**CITY OF PORTLAND, MAINE
DEVELOPMENT REVIEW APPLICATION
PLANNING DEPARTMENT PROCESSING FORM
DRC Copy**

Hersey Street Driveway
Project Name/Description

This letter is to summarize recent telephone conversations I have had with both Mr. Keaney and your site planner, John Schwanda regarding additional submittals that will be required in order for your application to be processed. The following list, generated by Planning Division staff, the Zoning Administrator, and the City's consulting civil engineer, provides a detailed outline of those submittals.

TO: Ethan Macomber Boxer– Planner
FROM: Jim Seymour – Development Review Coordinator, Sebago Technics, Inc.
RE: Additional Driveway onto Hershey St. – Keany Residence-115 Codman St.
DATE: September 30, 2004

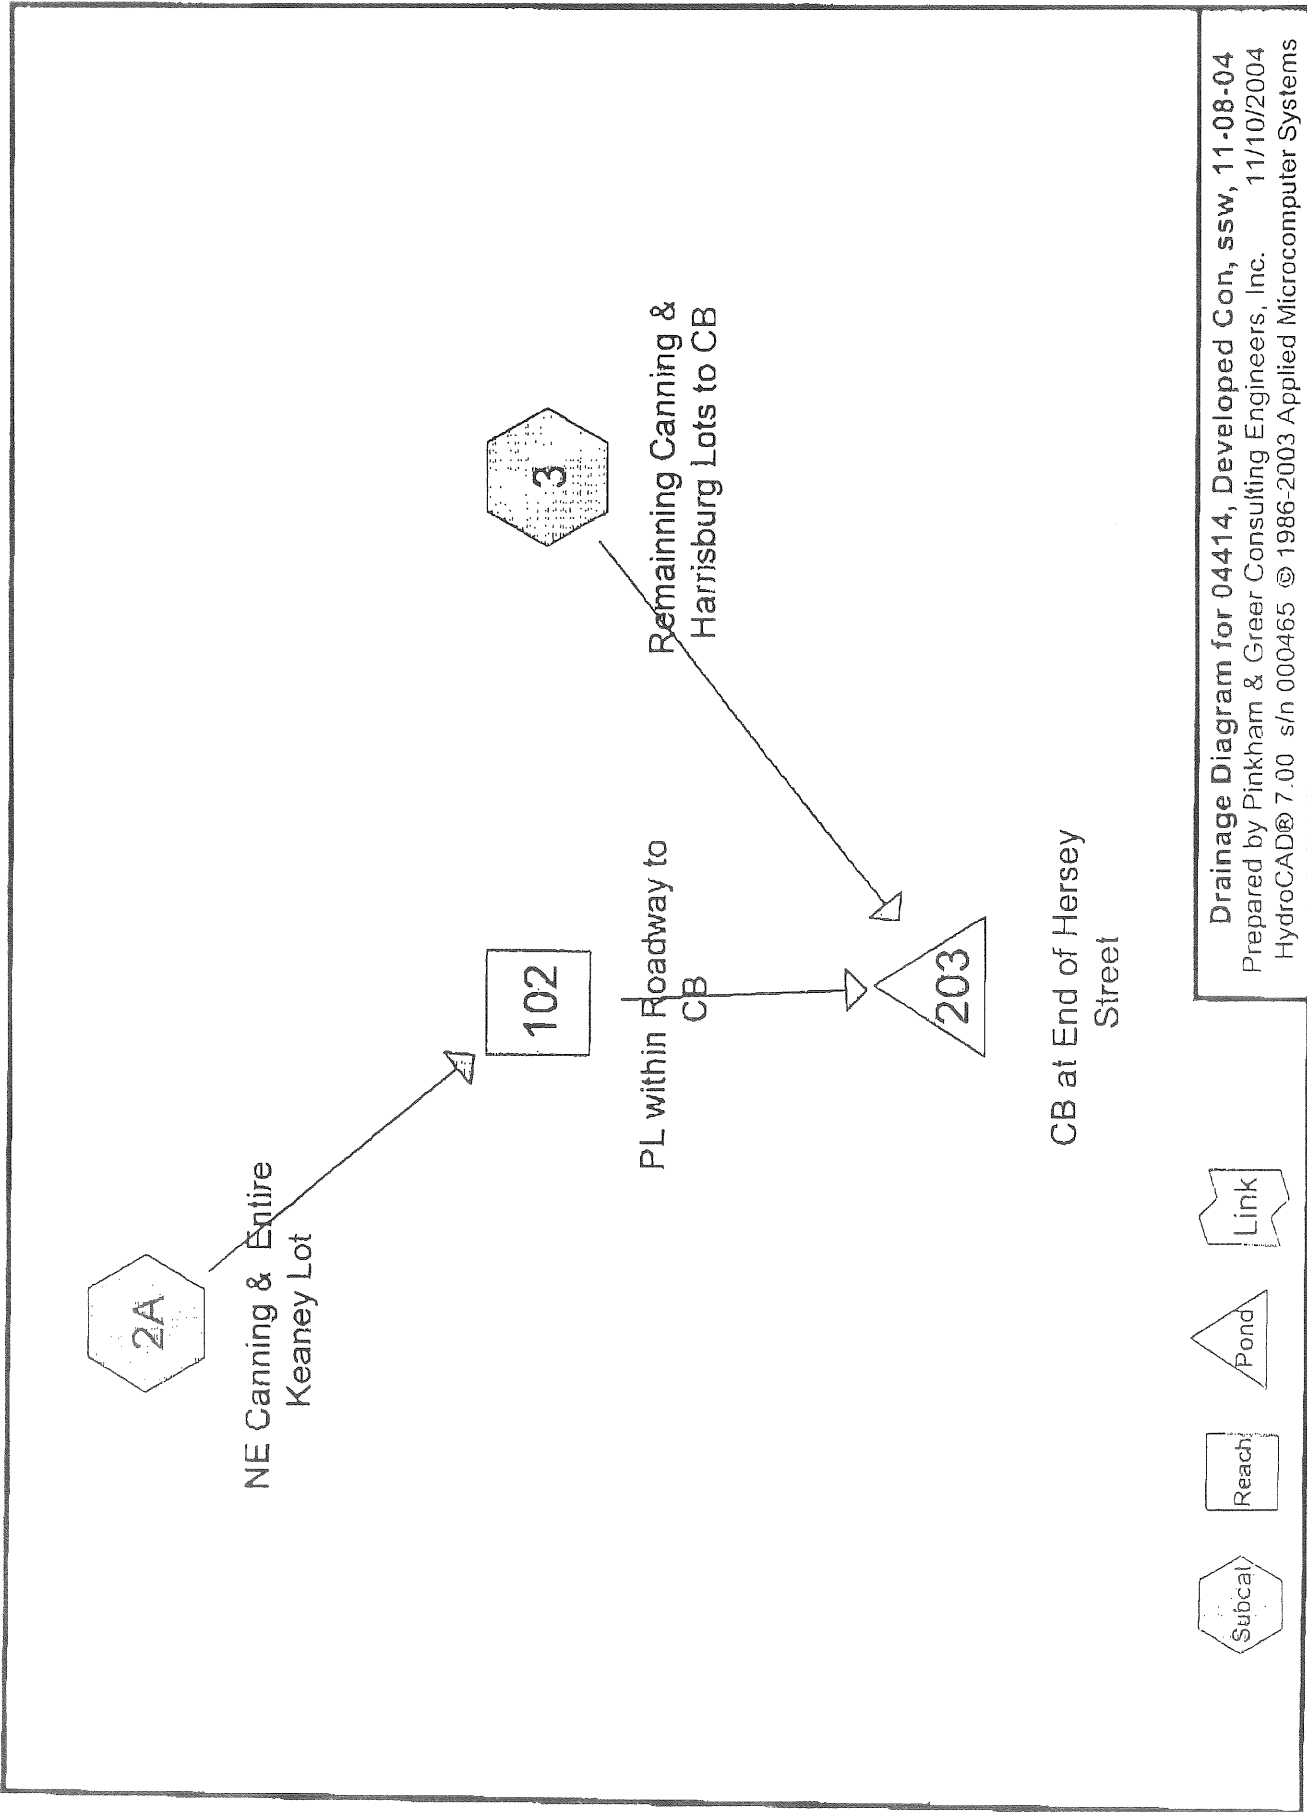
#	Routing	Invert	Outlet Devices
1	Primary	19.35'	8.0" x 250.0' long Culvert Ke= 0.500 Outlet Invert= 16.50' S= 0.0114 /' n= 0.013 Cc= 0.900

Primary OutFlow Max=1.74 cfs @ 12.05 hrs HW=22.96' (Free Discharge)
